Proposed Residential Development, Lisdaran, Cavan, Co. Cavan

Quality Audit

*including appended
DMURS Street Design Audit and Stage 1-2 Road Safety Audit*

Stage 1 Road Safety Audit

3.2 Problem: Boundary treatment west of northern internal junction

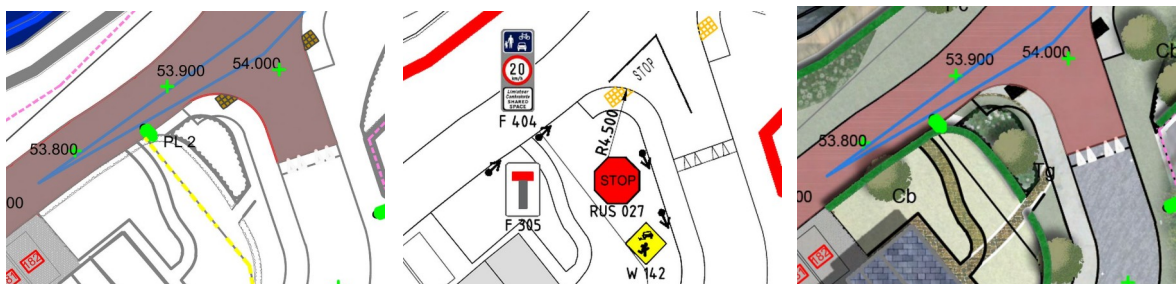
The proposed 2m high wall boundary positioned west of the northern internal junction will adversely impact on road-user safety through:

- Obstructing junction visibility splay to/from the west;
- Obstructing inter-visibility for northbound pedestrians stepping out from the adjacent private north-south pedestrian route onto the proposed shared-surface roadway (as depicted below left);
- Obstructing visibility of proposed road-signs, noting that the road signing is also obstructed by the proposed public lighting infrastructure (as depicted below centre);
- Obstructing safe access for the private east-west route pedestrian route at this locality (as depicted below right).

Ensure that boundary treatment at this locality does not adversely impact on road-user safety, revising this boundary treatment whilst taking full account of junction visibility splays, inter-visibility of pedestrians, pedestrian access routes, and road signing and public lighting infrastructure.

3.3 Problem: Vehicular access at north-western area of site

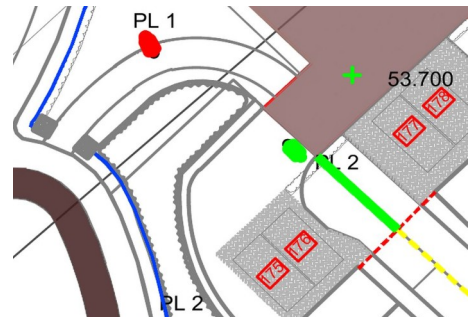
There is potential for those vehicles egressing from the north-western parking spaces (residential unit labelled A1) to collide with the adjacent proposed public lighting column. Additionally those vehicles reverse egressing from this parking area and the western parking space of the adjacent residential unit (labelled A2) will potentially collide with pedestrians accessing to/from the proposed north-western pedestrian route/shared-surface roadway.

Provide safe access for vehicular and pedestrian access in this area of the development site, revising the position of public lighting infrastructure and revising the alignment of the north-western pedestrian route, taking full account of vehicle swept path access.

3.10 Problem: Vehicle swept path encroachment over footpath

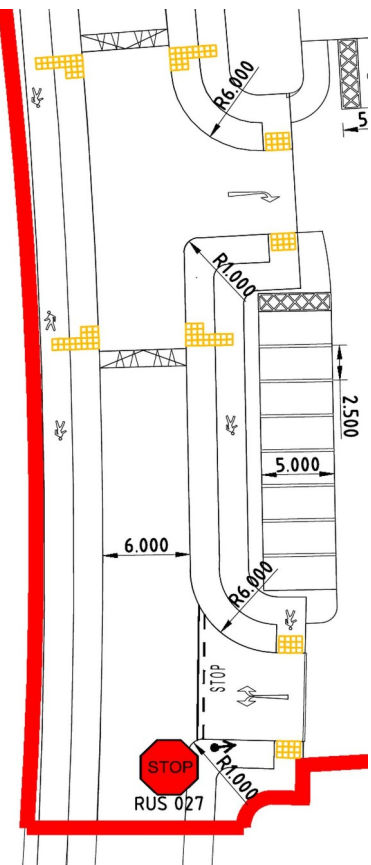
There is potential for injury to pedestrians as the swept path of large vehicles encroaches over the footpath route in the locality of residential unit labelled number 34.

Ensure that vehicles do not encroach over the footpath at this locality.

3.14 Problem: Residential unit boundary treatment masking inter-visibility

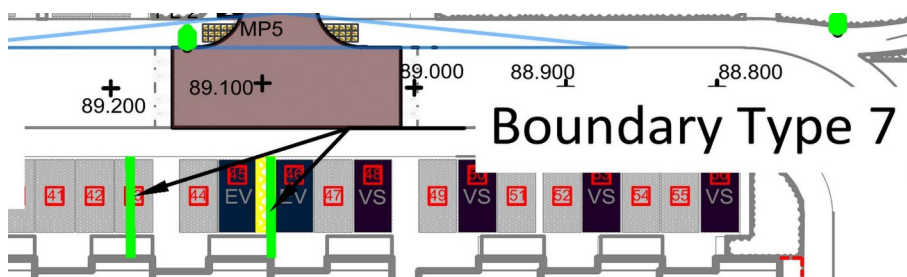
There is the potential for the boundary treatment proposed between the residential units to mask inter-visibility between those vehicles manoeuvring from/within curtilage parking spaces and those pedestrians (including child/youth pedestrians) traversing the adjacent footpath/shared-surface route or crossing points. This situation increases the risk of collisions involving these pedestrians.

Provide adequate inter-visibility between those vehicles manoeuvring from/within curtilage parking spaces and those pedestrians (including child/youth pedestrians) traversing the adjacent footpath/shared-surface route or crossing point, for example providing adequate off-set distance between this boundary treatment from the rear edge (non-carriageway edge) of the adjacent footpath.

3.18 Problem: Collision with public lighting infrastructure

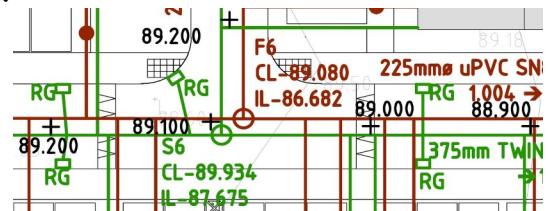
There is the risk of injury to road-users colliding with public lighting infrastructure positioned within turning heads, cycle routes, and footpath routes.
